April 6, 2020

RE: **Lot 23 Block 2 S.A.D. 227 Unit 5**
6505 Popo NW
Grading and Drainage Plan
Engineers Stamp Date 4/3/20 (E10D076)

DRAINAGE AND TRANSPORTATION INFORMATION SHEET (REV 6/2018)

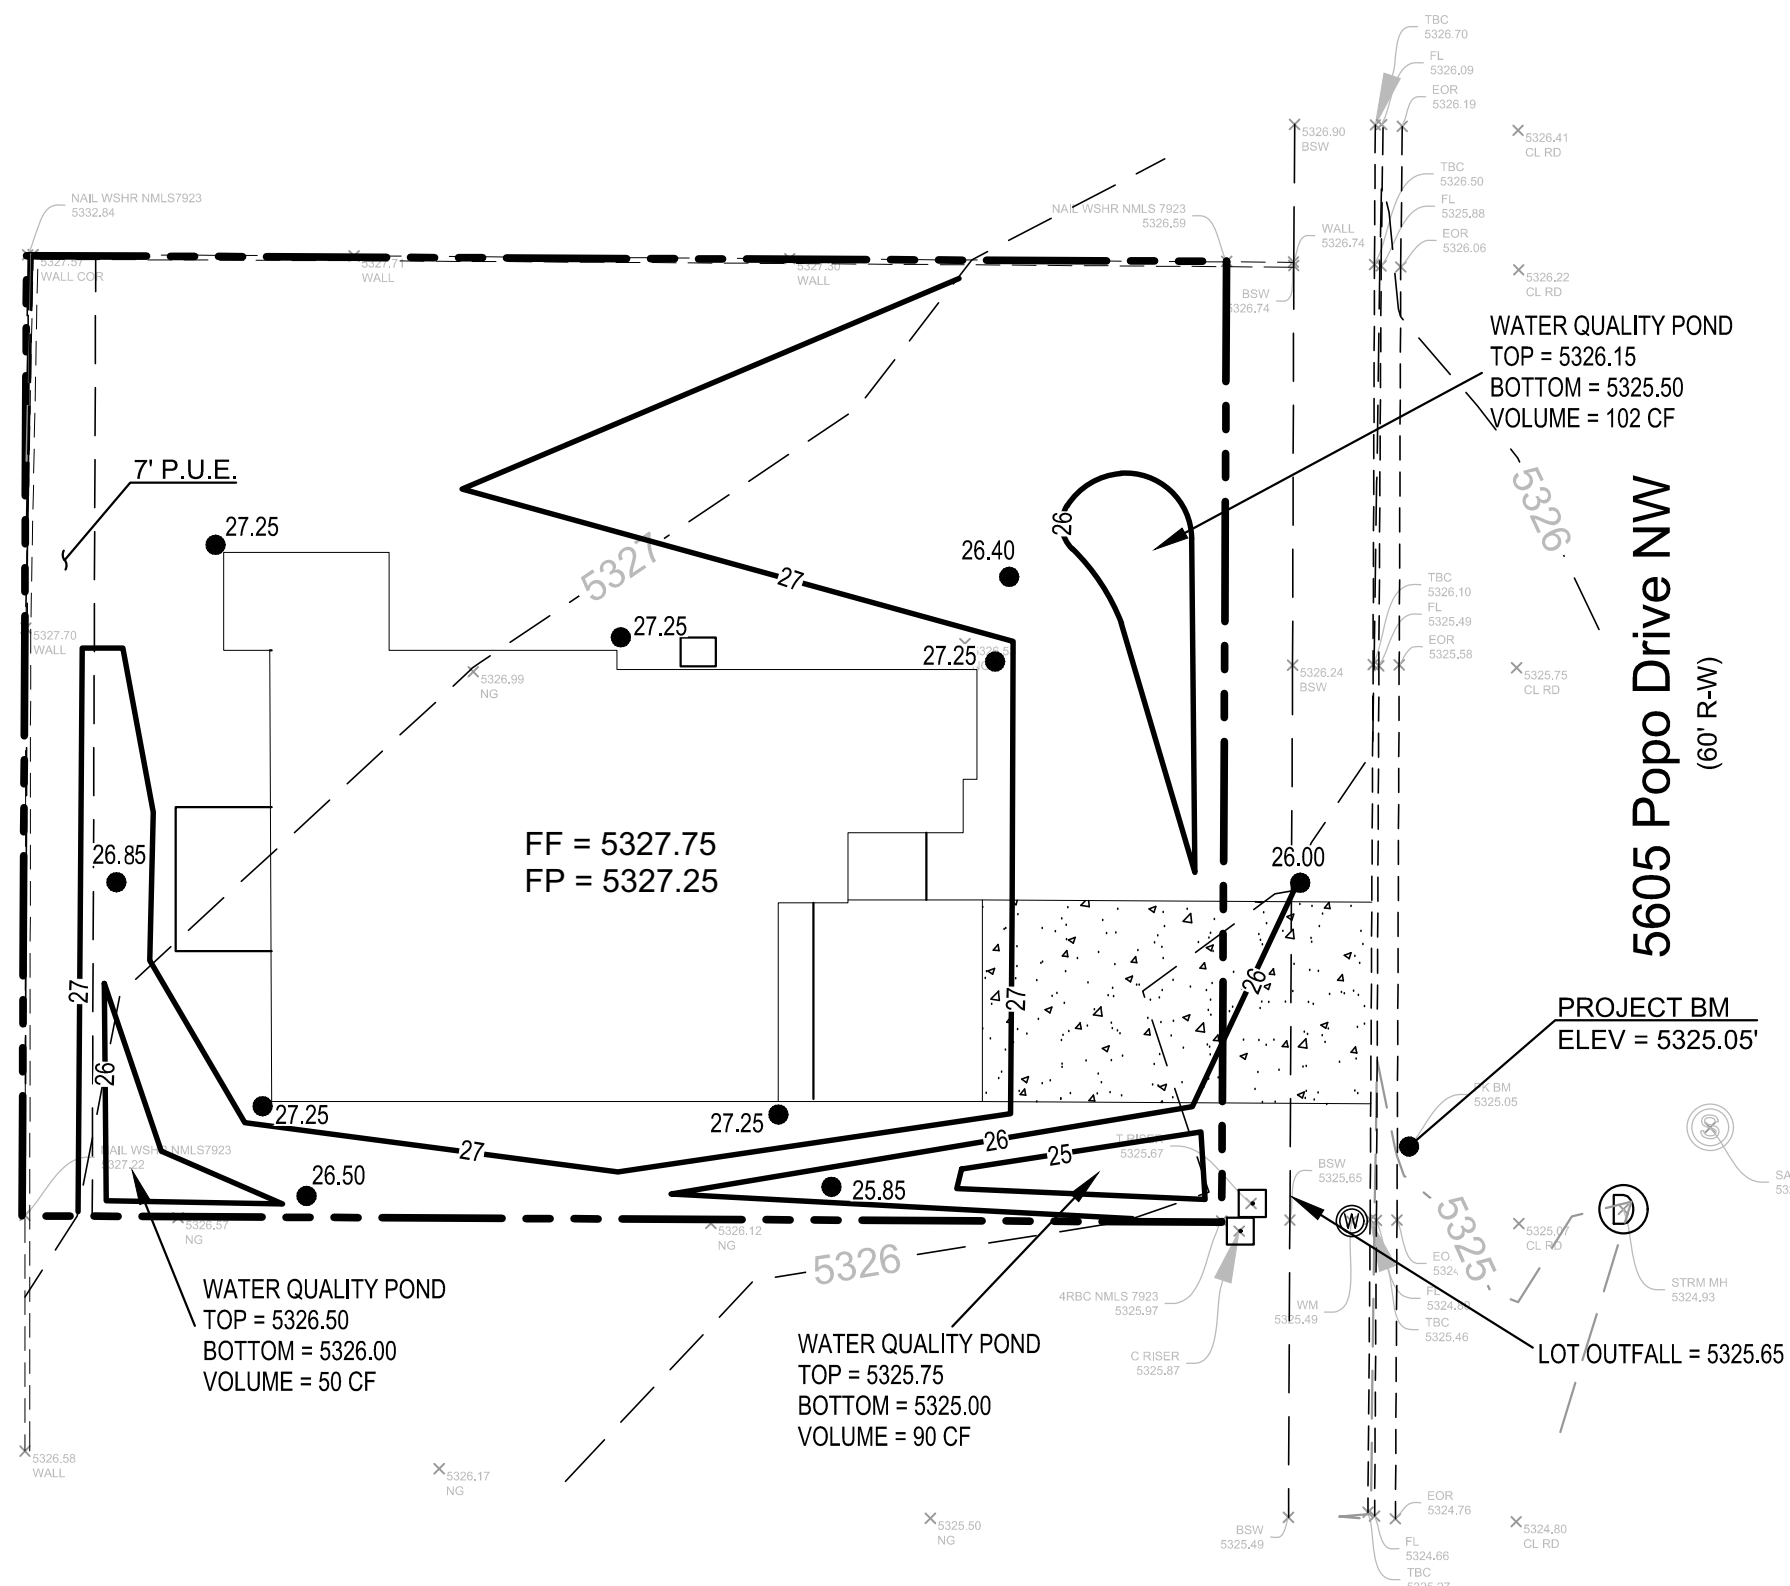
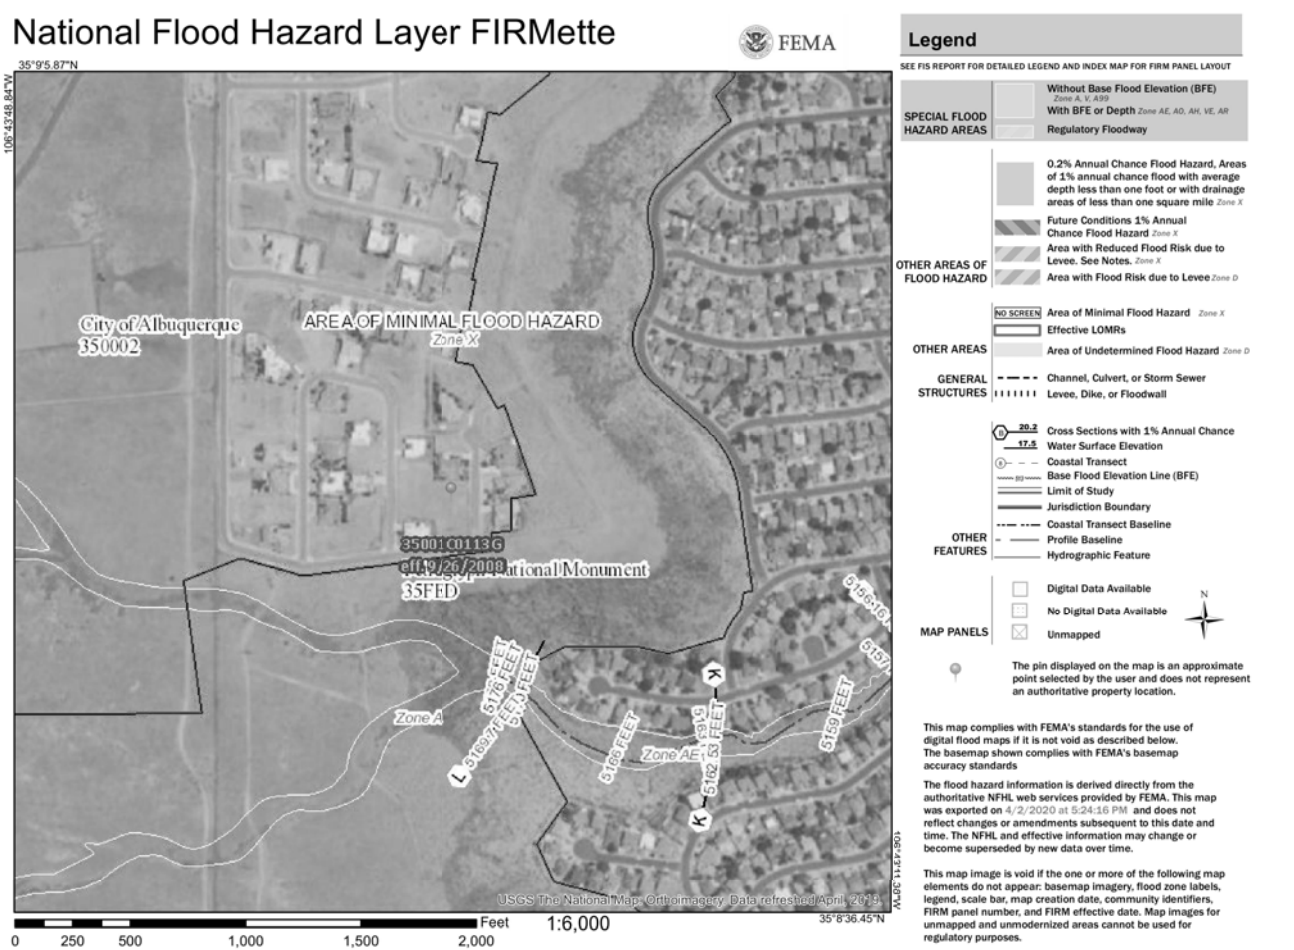
Based upon the information provided in your submittal received 4/6/20, this plan is approved for Grading Permit. Please inform the builder/owner to attach a copy of this approved plan and letter into the construction sets in the permitting process prior to sign-off by Hydrology.

Reiterate to the Owner/Contractor that a separate permit for any garden/retaining wall must be obtained, with the approved G&D plan.

Prior to Building Permit approval, a **Pad Certification** will be required. Inform the contractor/owner not to pile dirt in the street as a ramp to climb the curb. If dirt is found in the street the pad cert. will be denied.

Prior to **Certificate of Occupancy release**, Engineer Certification per the DPM checklist of this plan will be required.
